Proffer Surgical Center Addition Addendum 1

February 17th, 2018

Please allow the following identified on this three page document and three page attachment to serve as addendum one for the Proffer Surgical Center Addition Project.

CONCRETE PAVEMENT SECTIONS

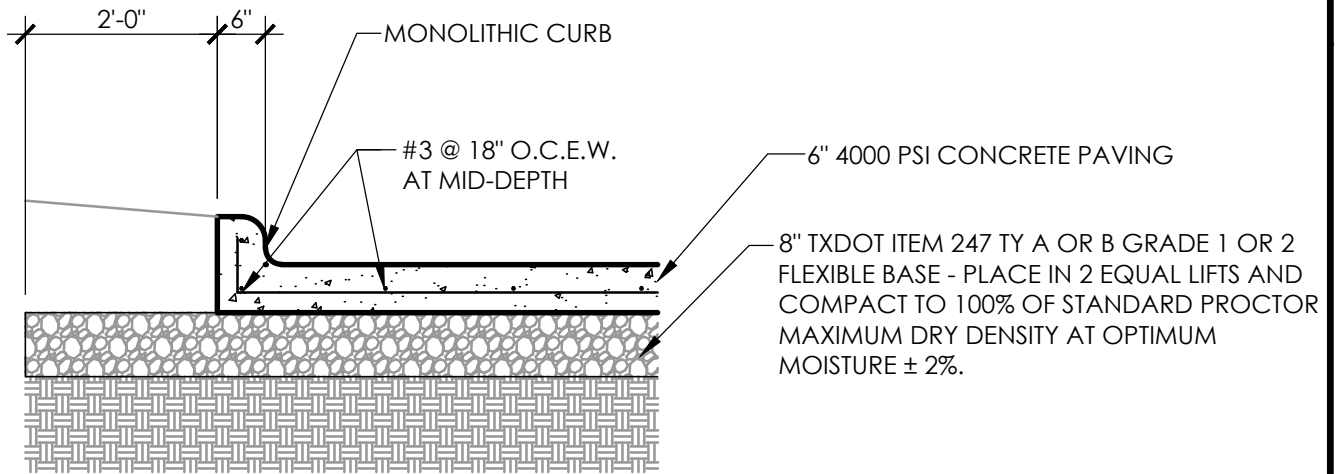
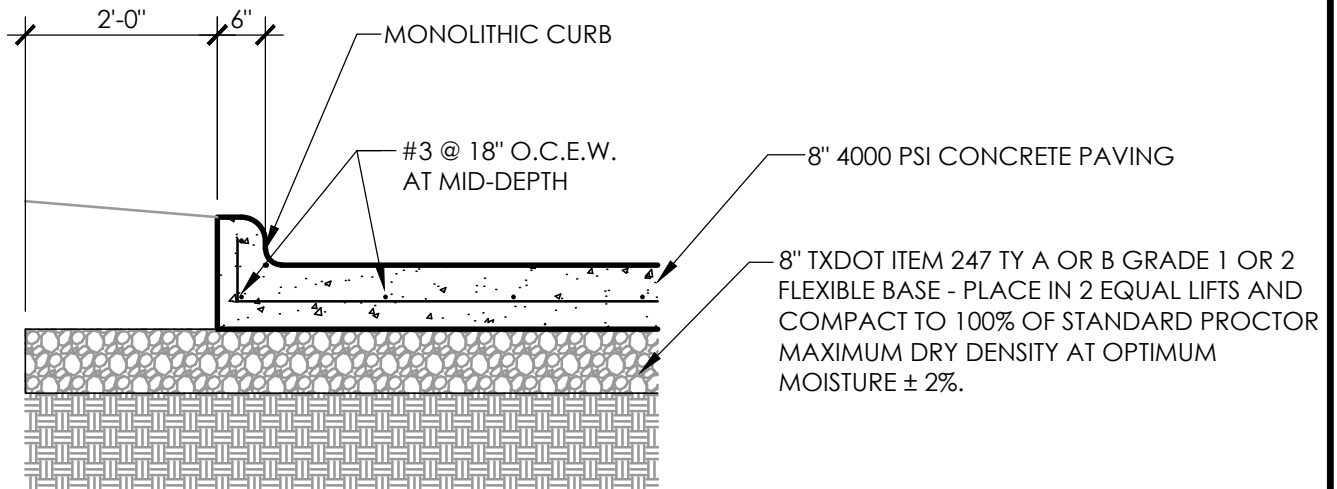
- Sheet C-2 **Add** the following details – Attachments 1 through 3.
Attachment 1 / Detail 1 - “Concrete Pavement Sections”.
Attachment 2 / Detail 2 - “Drainage Channel Profile”.
Attachment 3 / Detail 3 – “Expansion Joint Profile”.

- Sheet C-2 **Add** the following General Note 1:
Review both C sheets and S sheets to fully comprehend extent of earthwork scope.
- Sheet C-3 **Substitute** the following for General note 4:
New pavement to match existing – density, reinforcement, depth and profile. Driveway pavement shall be 8” and parking stall pavement shall be 6”. See attachment 1, Detail 1 added to sheet C-2 – Concrete Pavement Sections.

6" subgrade scarified and recompact to 100% of standard proctor dry density at optimum moisture content to + 4% of optimum. Determine PI of existing material. If PI is greater than 15, stabilize subgrade with hydrated lime or cement kiln dust (CKD). Amount of lime or CKD to reduce subgrade PI below 15 shall be determined by additional testing. All testing shall be performed by a professional engineer licensed in Texas. For bidding purposes assume 6% lime required for stabilization.

8" subgrade scarified and recompact to 100% of standard proctor dry density at optimum moisture content to + 4% of optimum. Determine PI of existing material. If PI is greater than 15, stabilize subgrade with hydrated lime or cement kiln dust (CKD). Amount of lime or CKD to reduce subgrade PI below 15 shall be determined by additional testing. All testing shall be performed by a professional engineer licensed in Texas. For bidding purposes assume 6% lime required for stabilization.

DRAINAGE CHANNEL PROFILE

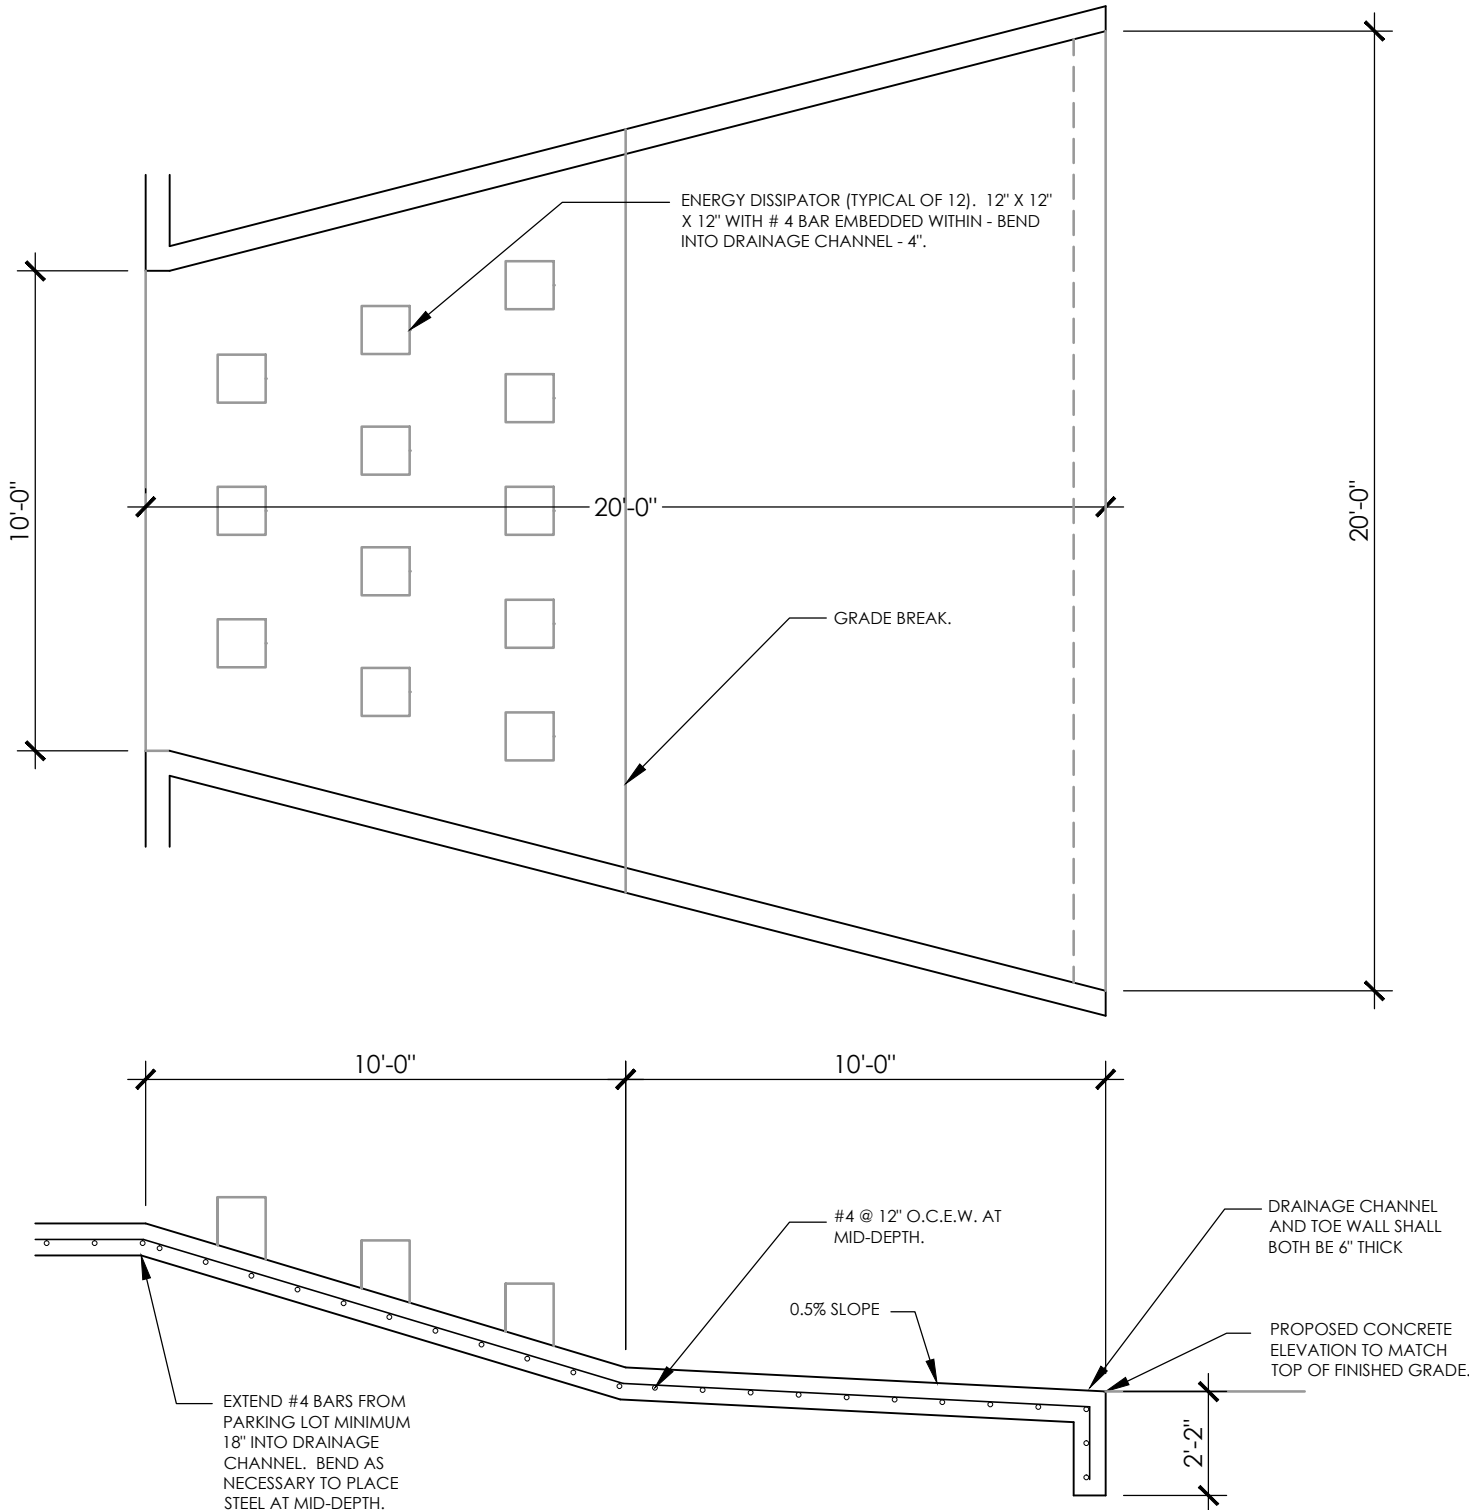
- Sheet C-3 **Add** the following sentence to Keyed note 12:
Detail as per attachment 2 / detail 2, sheet C-2.
- Sheet C-3 **Add** the following sentences to Keyed note 16:
New sidewalk is 5” thick with 6” curb. Pavement is to slope away from building at 2% cross slope maximum.
